SOUTH MERIDIAN & 43RD AVE SE
4227 S MERIDIAN
SUITE E
PUYALLUP, WA 98373

ADDENDUM - REVISION #3

DESCRIPTION: REVISED DRAWINGS ARE PER FIELD COORDINATION REGARDING SITE CONDITIONS THAT REQUIRED THE (2) RTU'S TO RELOCATE.

SHEETS AFFECTED: G000, AD131, A131, M101, M102, E101, E301,S102, S201 .

MECHANICAL FLOOR
PLAN

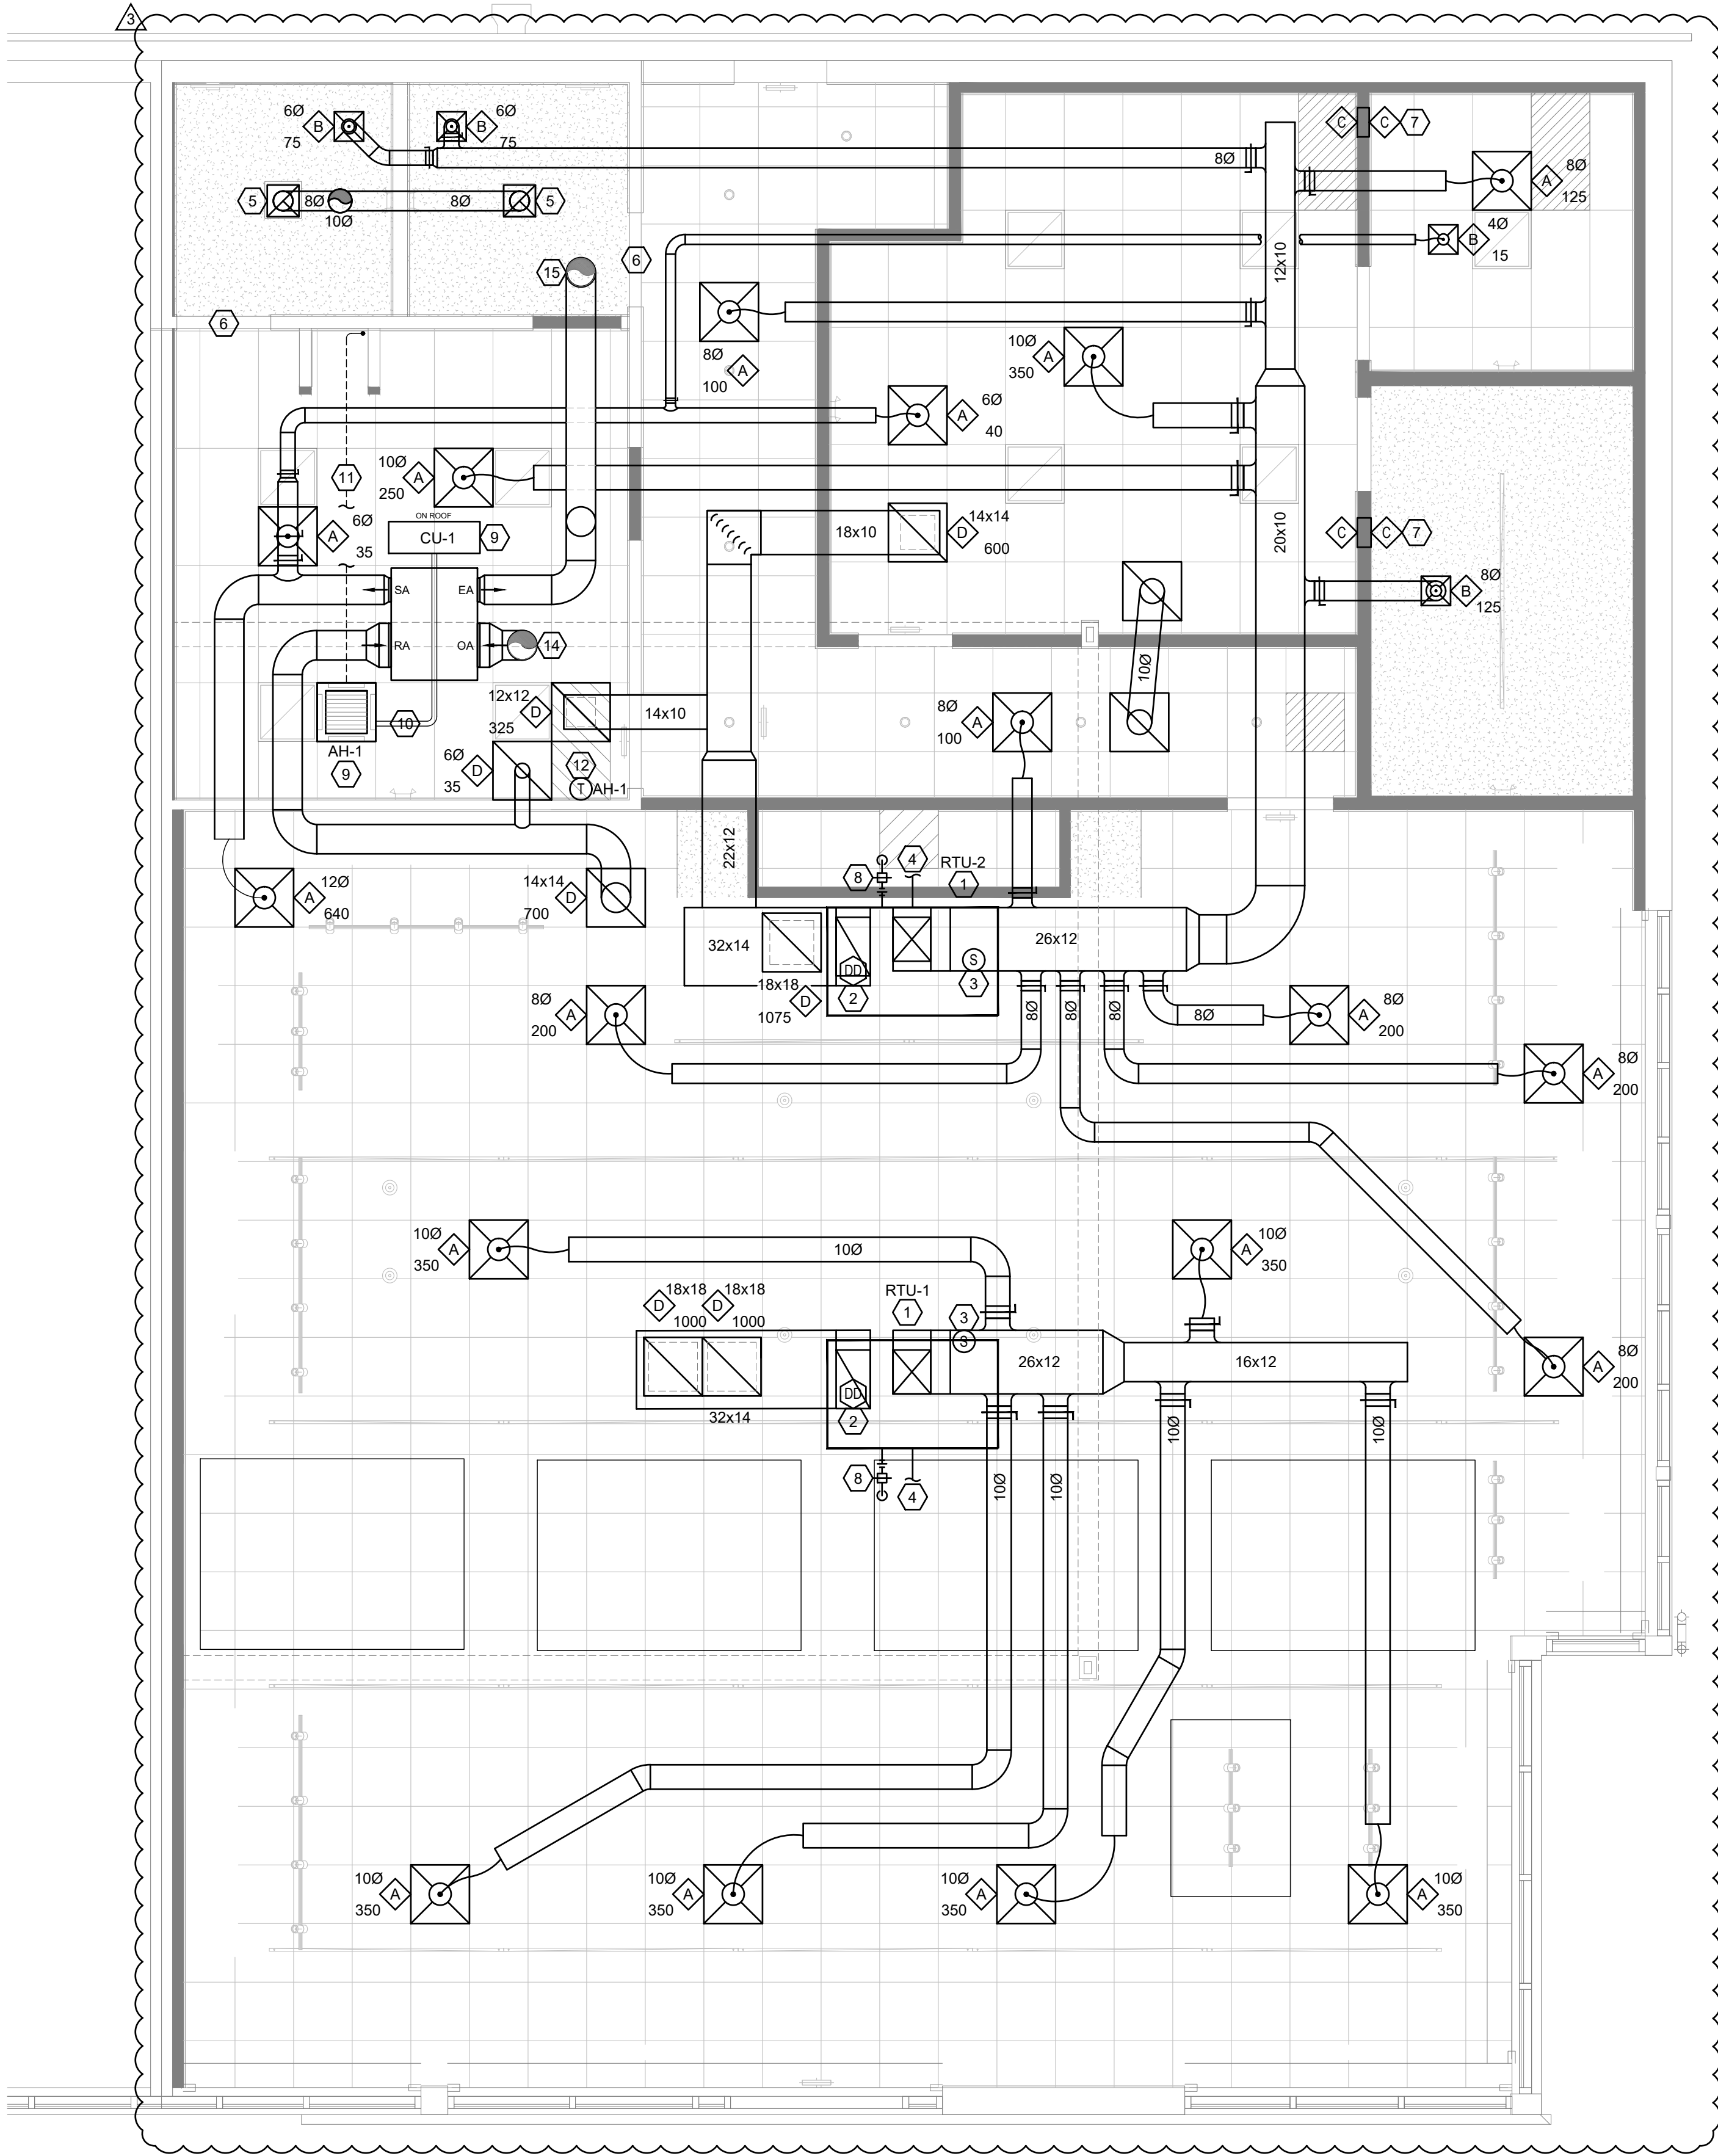
##	DESCRIPTION	DATE
3	CONSTRUCTION COORDINATION	3/11/2025
